**Environmental
Planning
Commission**

*Agenda Number: 06
Project Number: 1005280
Case #: 16EPC-40022
May 12, 2016*

Staff Report

Agent	HCI Engineering
Applicant	Palo Alto, Inc.
Request	Site Development Plan for Building Permit Amendment
Legal Description	Lot 1, McMahon Marketplace
Location	Near the SE corner of the intersection of Unser Blvd. NW and McMahon Blvd. NW (10600 Unser Blvd. NW)
Size	1.2 acres
Zoning	SU-1 for C-1 uses including grocery store with package liquor sales incidental to that use, restaurant with full-service liquor for on-premise consumption

C1.0

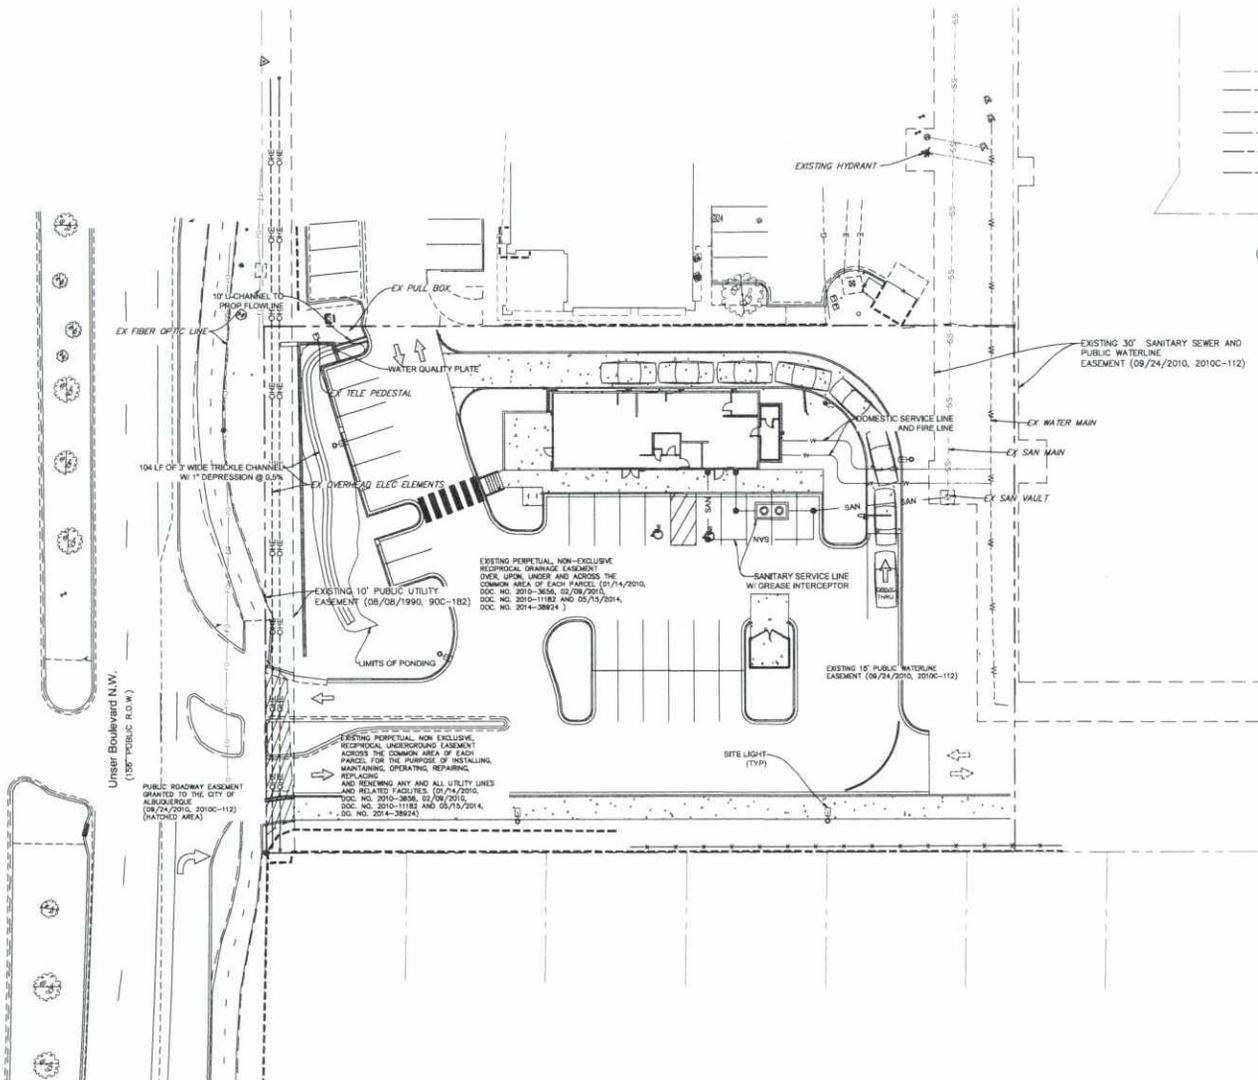
- A. Use a consistent symbol for the existing retaining wall (Sheet C1.0).
- B. The patio area shall be dimensioned and clearly indicated (Sheet C1.0).
- C. Keynote the bench (Sheet C1.0).
- D. Add a scale and north arrow to the landscaping plan (Sheet L1.0).
- E. Specify which color is to be used for the landscape gravel (Sheet L1.0).
- F. Keyed note 1 shall be revised to refer to “monument sign”, not “marquee sign” (Sheet C1.0).
- G. Label the elevations using directions (Sheets A4.0 and A4.1).

A4.0

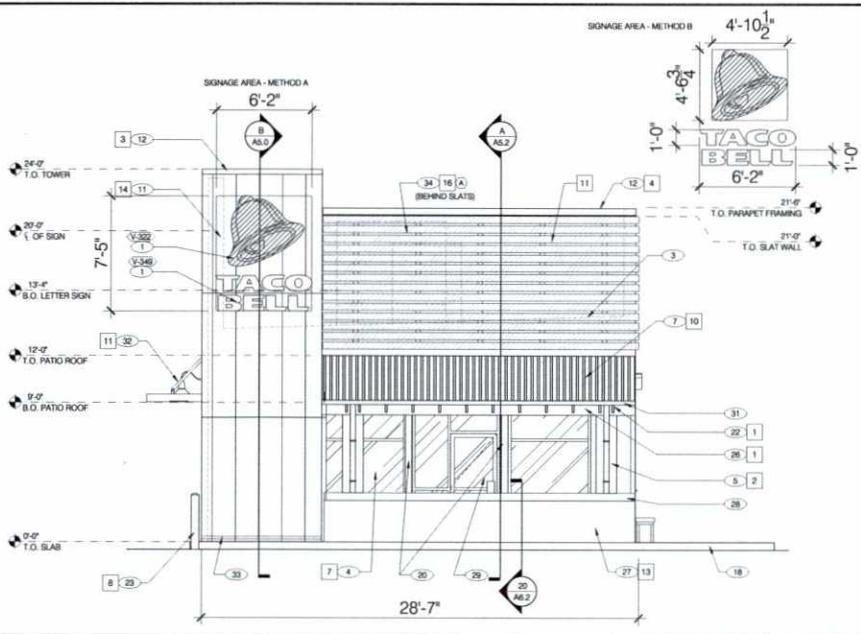
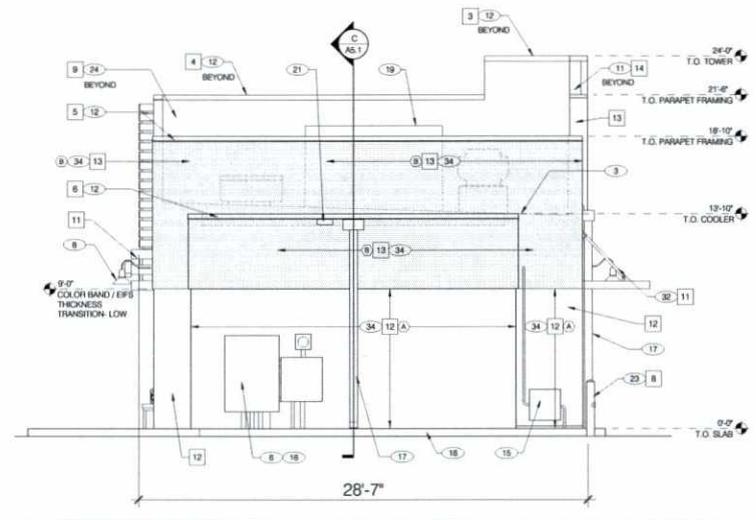
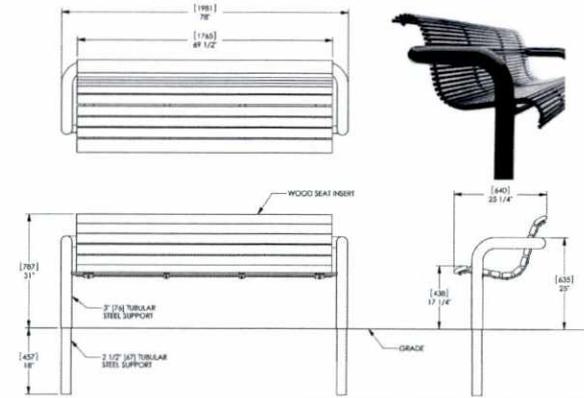
The proposed building's architecture is a modern design associated with the particular fast-food franchise (franchise architecture). The proposed design is a major departure from the approved elevations of the site development plan for building permit, which is why the applicant is requesting to amend the site development plan for building permit.
